Wollongong Local Planning Panel Assessment Report | 17 February 2021

WLPP No.	Addendum Report to WLPP Item 1 - 3 November 2020
DA No.	DA-2020/572
Proposal	Residential - multi dwelling housing - demolition of existing warehouse storage facility and construction of 12 x two storey dwellings.
Property	481-485 Princes Highway, WOONONA NSW 2517 Lot 1 DP 86796
Applicant	MMJ Wollongong
Responsible Team	Development Assessment and Certification – City Wide Planning Team (SG)

ADDENDUM REPORT

SP 8

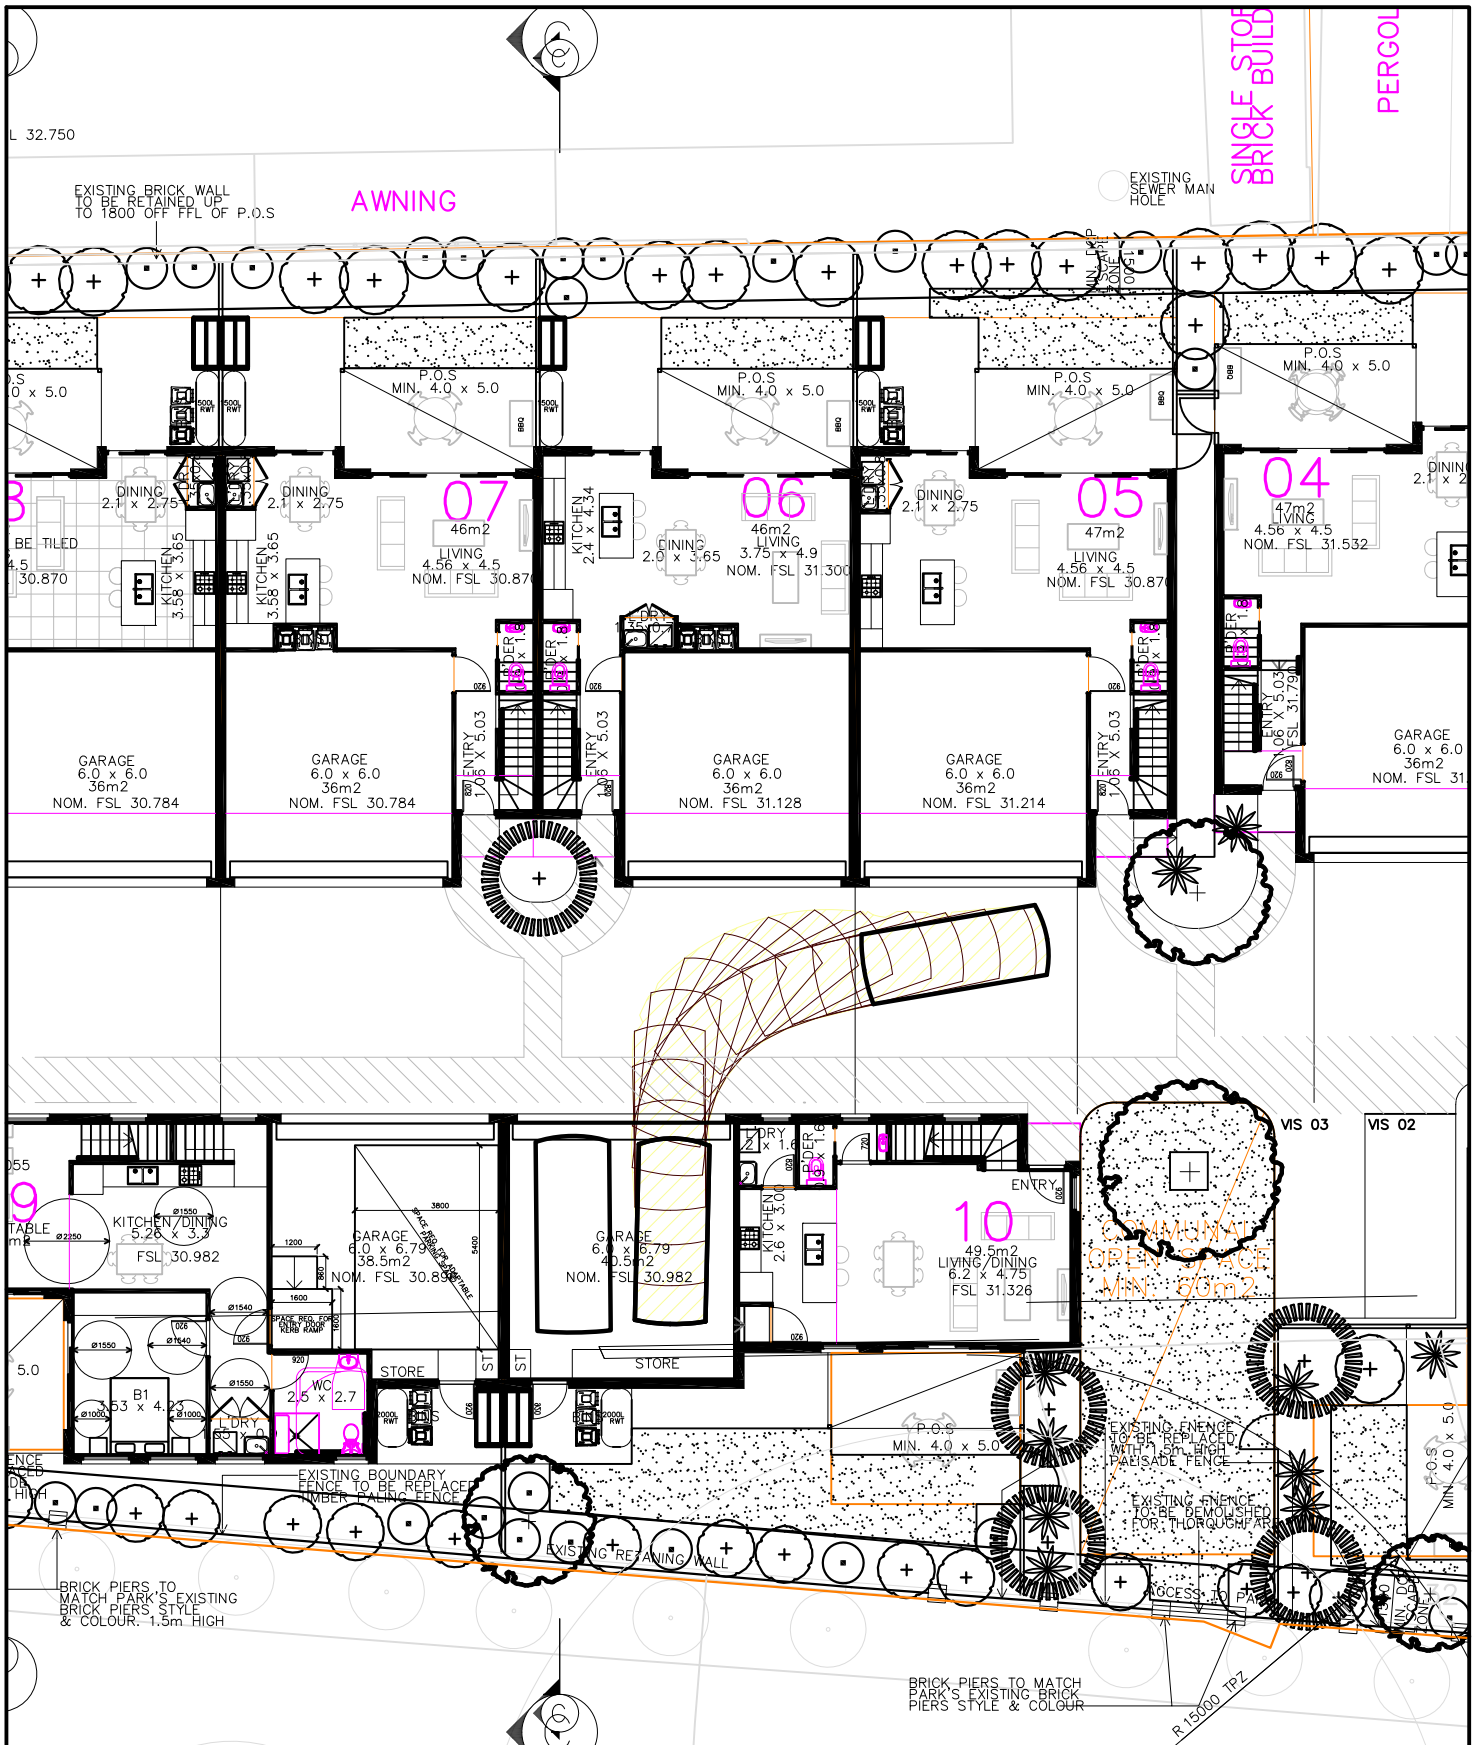
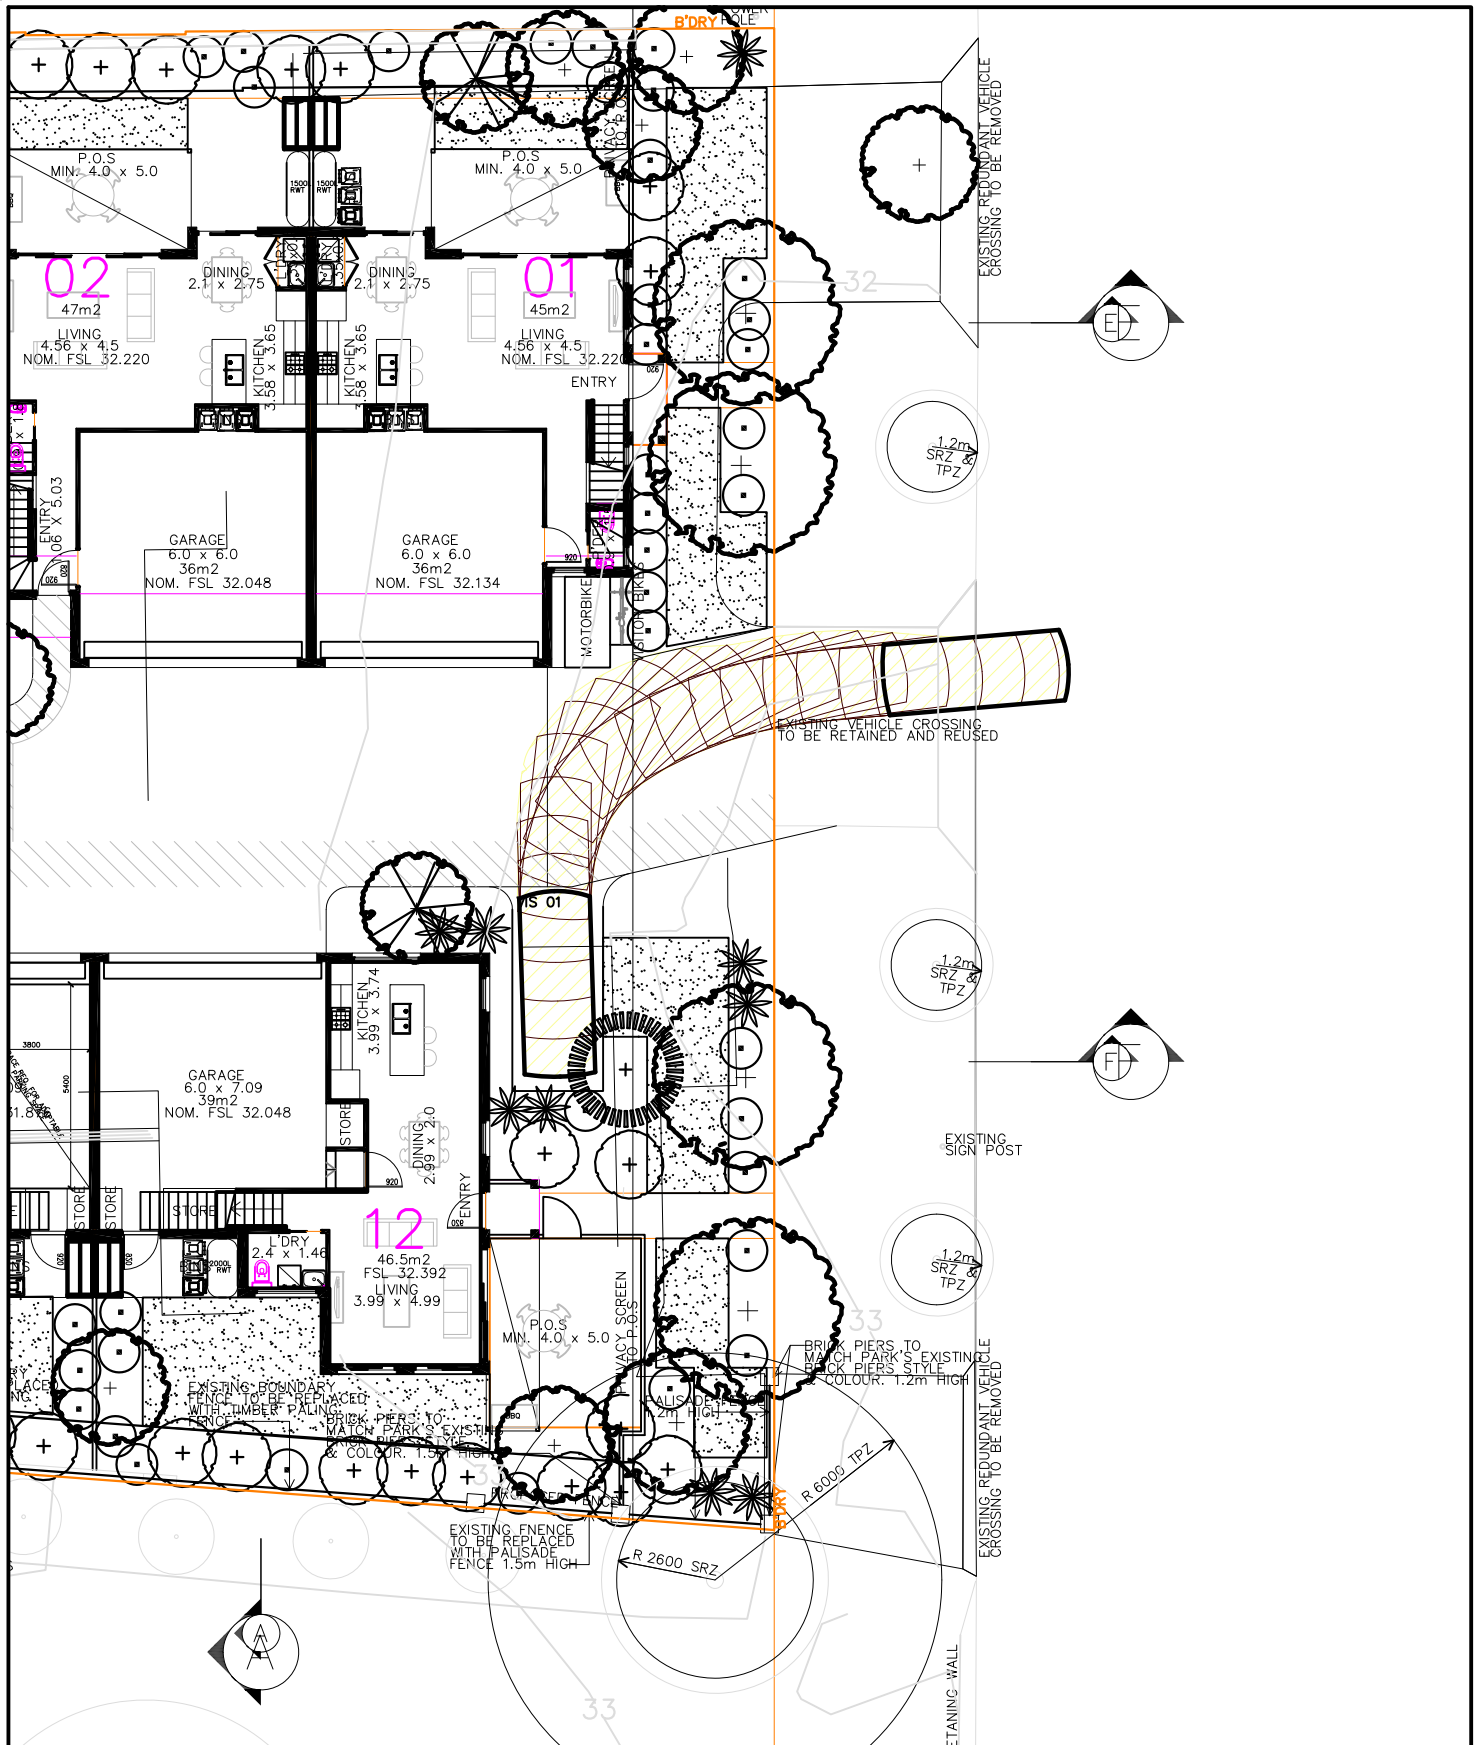
- *The visitors' spaces appear too narrow and are positioned in locations which prevent manoeuvring of vehicles in a forward gear. These need to be enlarged and relocated. It may result in a reduction in GFA. The Panel considers that locating visitors' spaces and turning facilities in direct proximity to dwellings front doors is undesirable from an amenity and safety perspective.*

It is confirmed that the visitor spaces are in fact the correct size to meet compliance with the Australian Standards. Please refer to AR 101 revD and AR151 revC where the spaces are now clearly dimensioned. Reference should also be made to the swept paths provided by TTPA traffic engineers demonstrating this compliance ingress and egress vehicle movements. Specifically the templates SP4,5,6, 7, 17 and 18.
